## **ADDENDUM #1**

*June 23, 2016*

# **CDBG PY15-003** **West Yavapai Guidance Clinic** *Drainage and Parking Lot Improvements*

WEST YAVAPAI GUIDANCE CLINIC  
DRAINAGE IMPROVEMENT PLANS  
SECTIONS, PROFILES & DETAILS

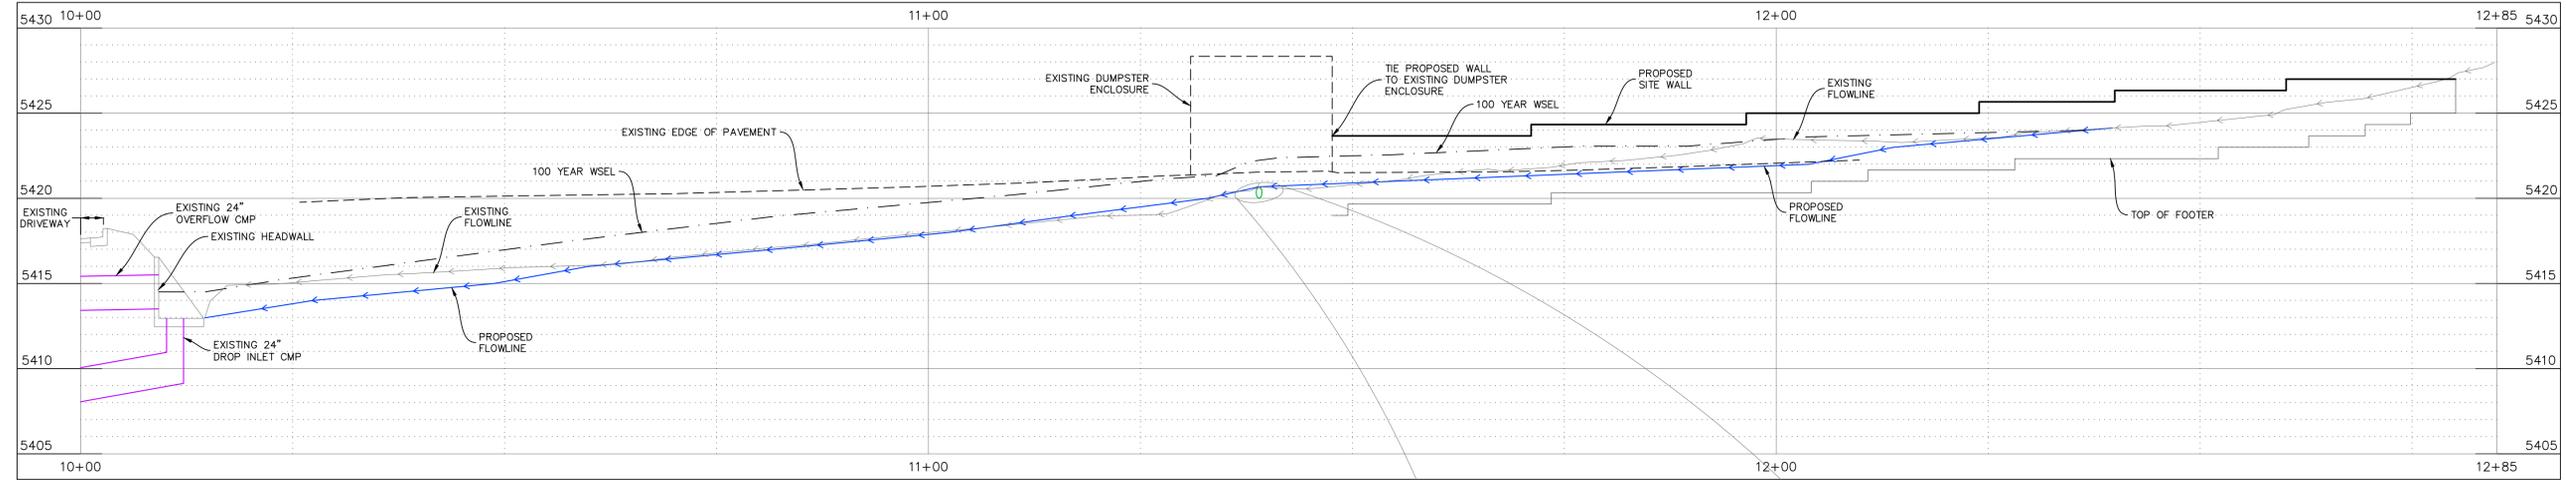
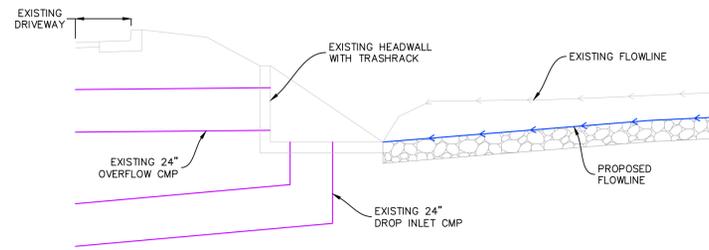
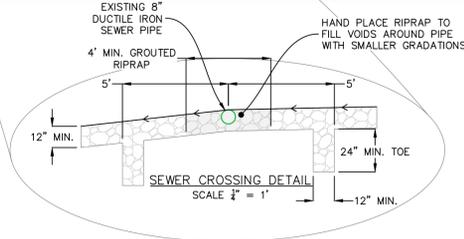
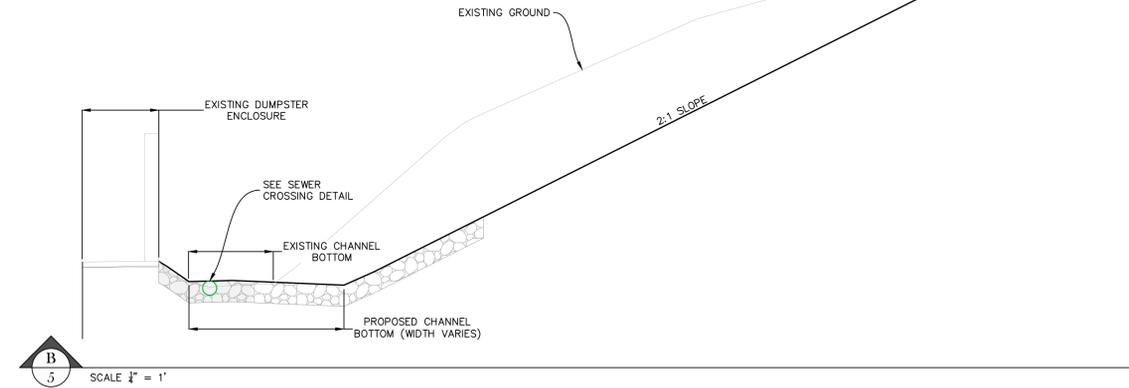
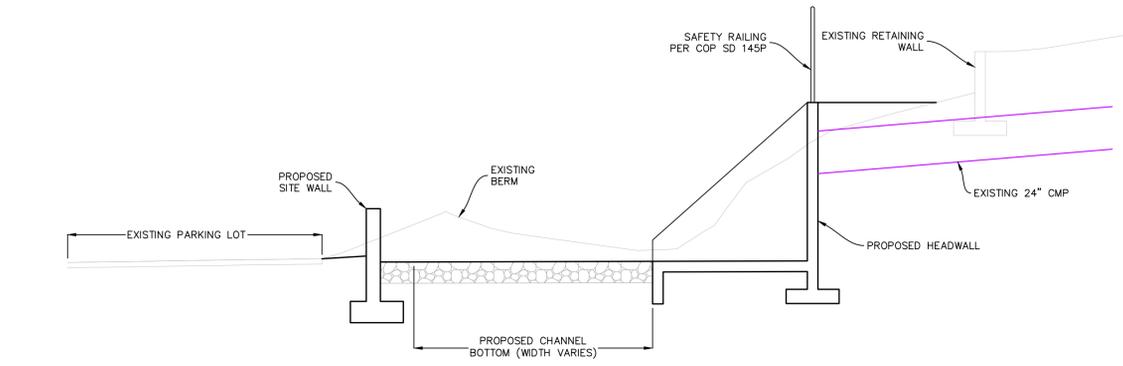
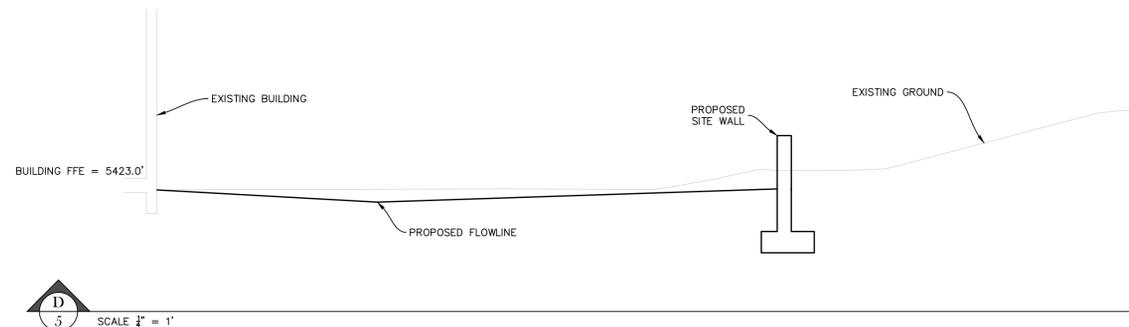
3. Question: Will work be paid as a lump sum contract or by installed quantities? If by installed quantities, how are items 7 head wall and 8 site wall measured? (Note: My calculation for item 8 is about 620 SF including height of footing. Engineer's calc is 500 SF.) ( I don't know how the engineer measures the headwall in SF as there is vertical wall above the slab; there is also the slab, curb, stem wall and footing.)

Answer: The Contractor will be paid based on installed quantities. The area quantity for Item #7 (Headwall) is measured based on the square footage of concrete illustrated by the headwall detail, profile and section on Sheet 3 of 6 (reported area includes slab, vertical walls and toe). The area quantity for item #8 (Site Wall) is based on the square footage of stem above the footing illustrated by the wall elevation on Sheet 3 of 6. Please note we have similar findings when the footing is included in the measurement (490±SF for the stem and 130±SF for the footing).

WEST YAVAPAI GUIDANCE CLINIC  
DRAINAGE IMPROVEMENT PLANS  
EROSION CONTROL PLAN

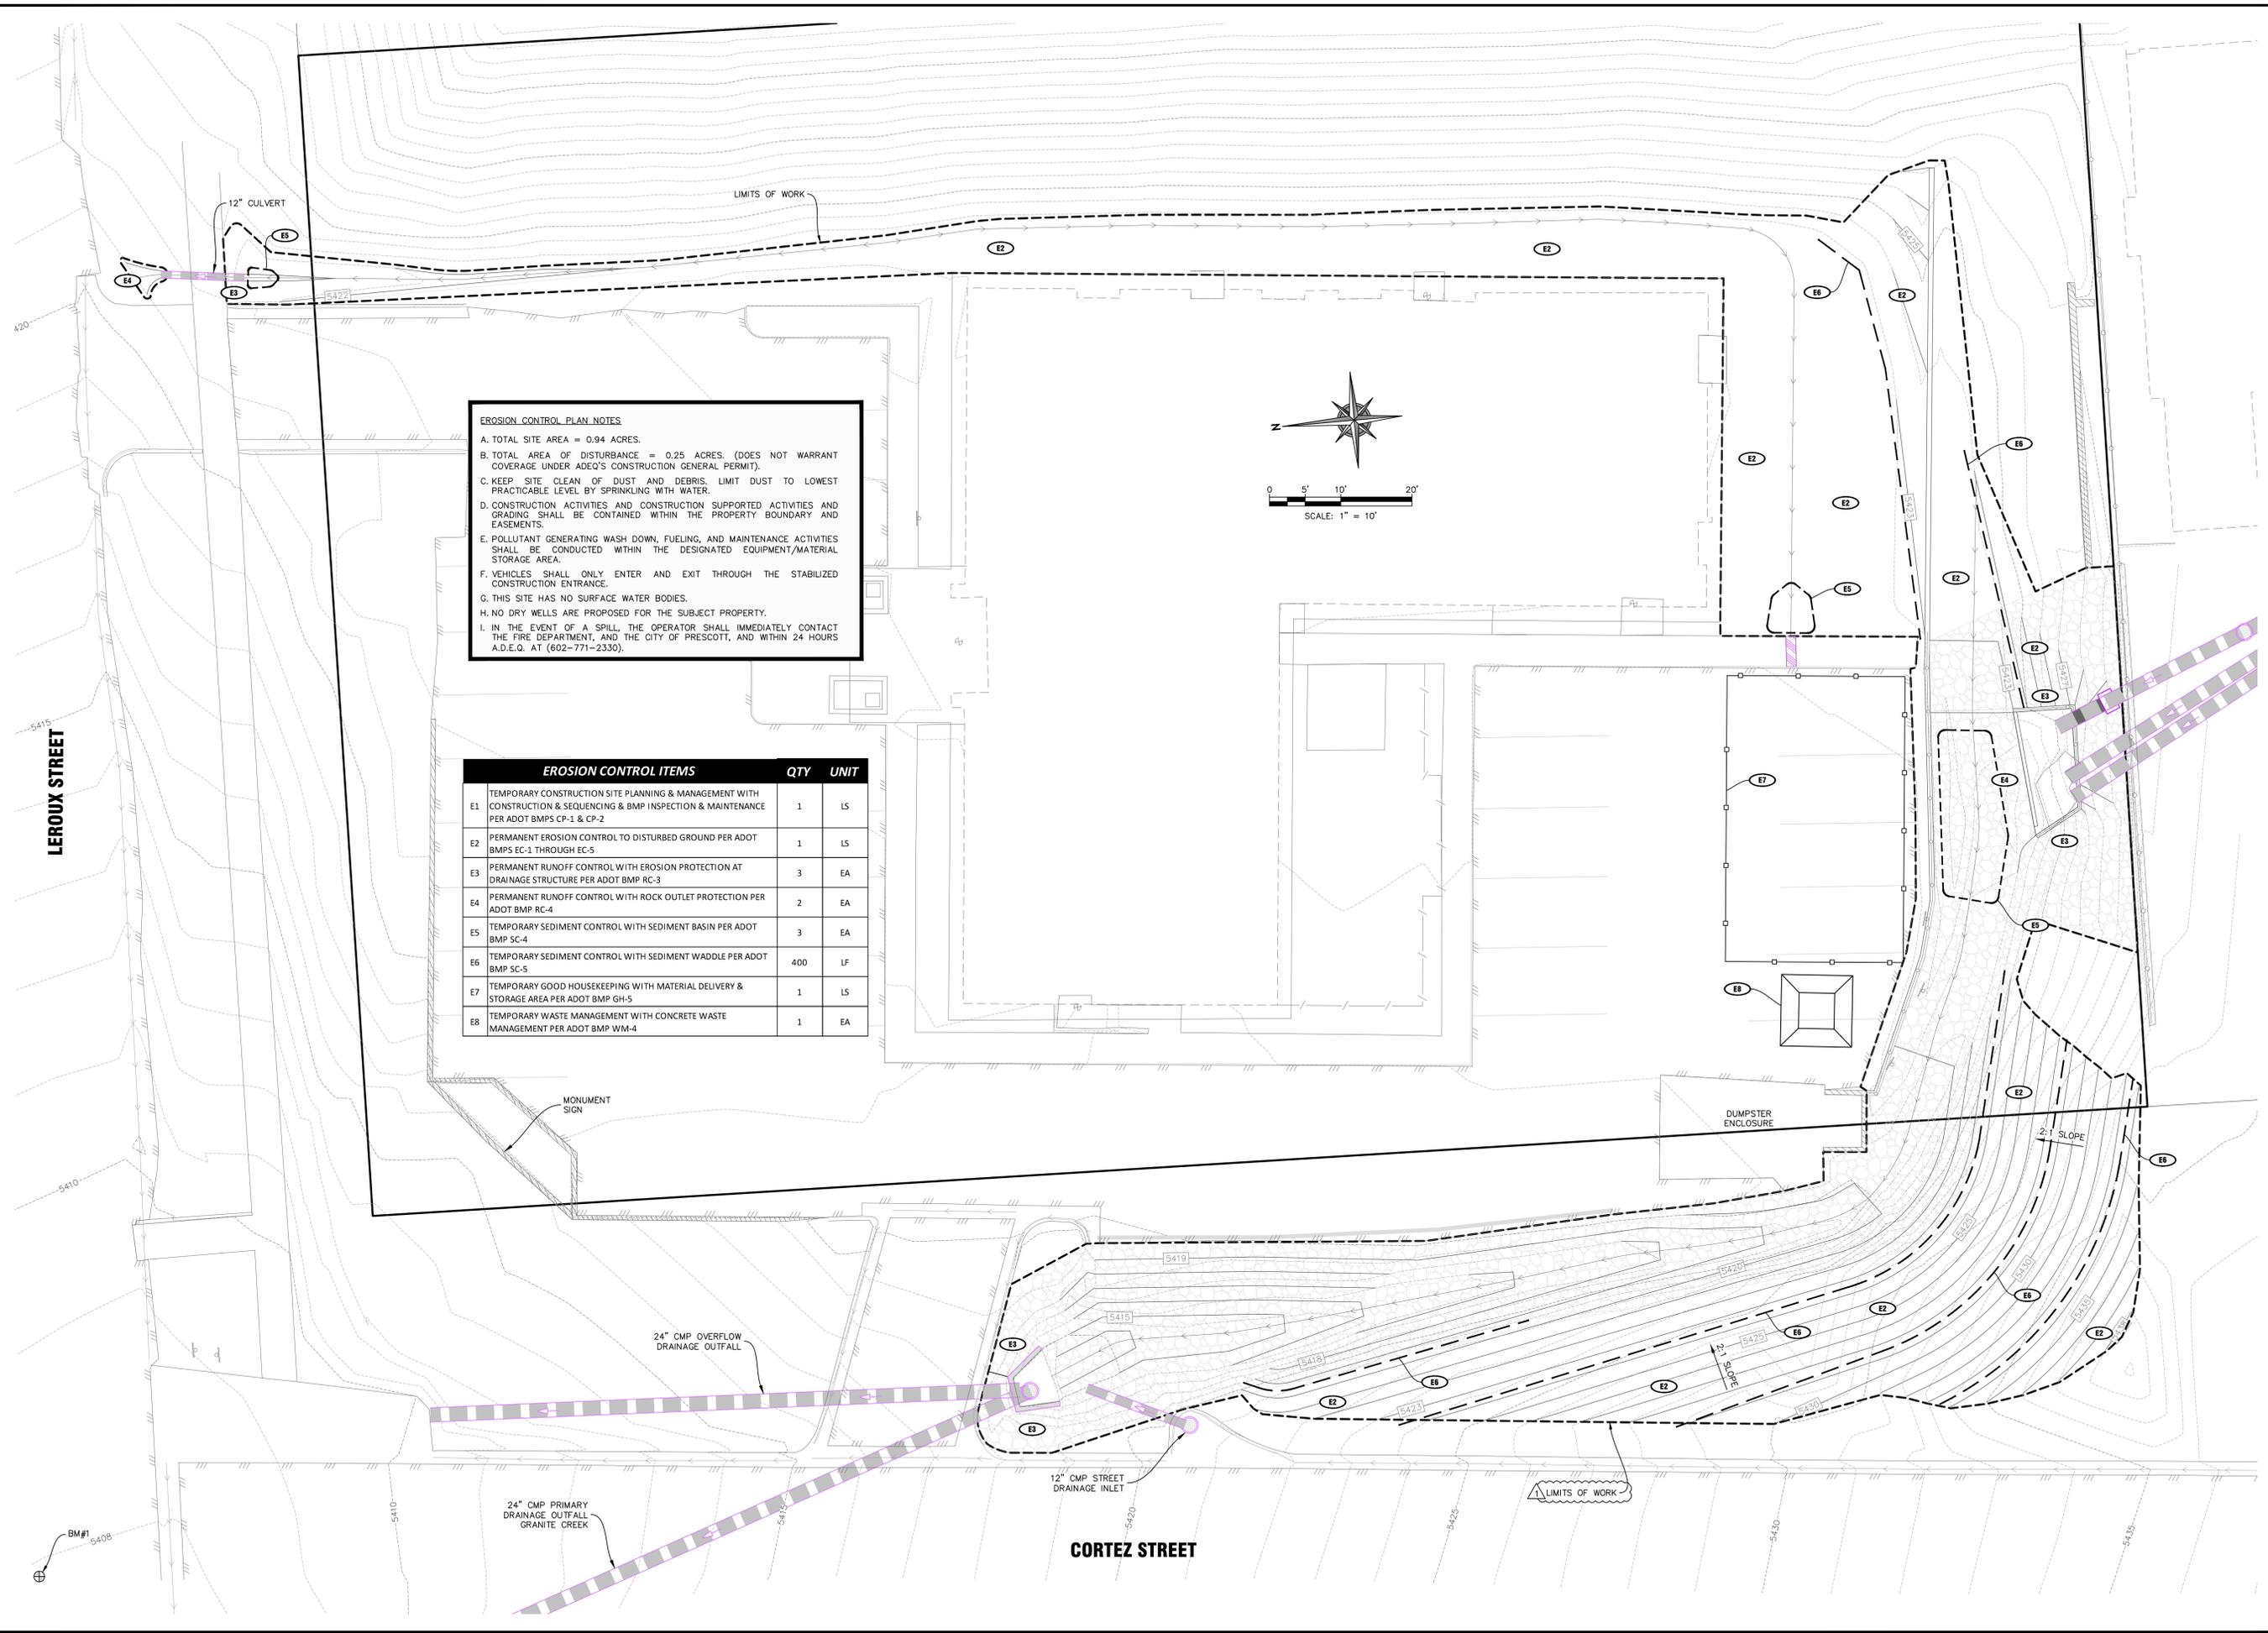
9. Question: Hydroseed clarification?

Answer: Permanent erosion control to disturbed ground shall be done in accordance with the Plans (see Erosion Control Plan, Sheet 6 of 6). Erosion Control Item "E2" references ADOT BMPs EC-1 through EC-5 which includes seeding.
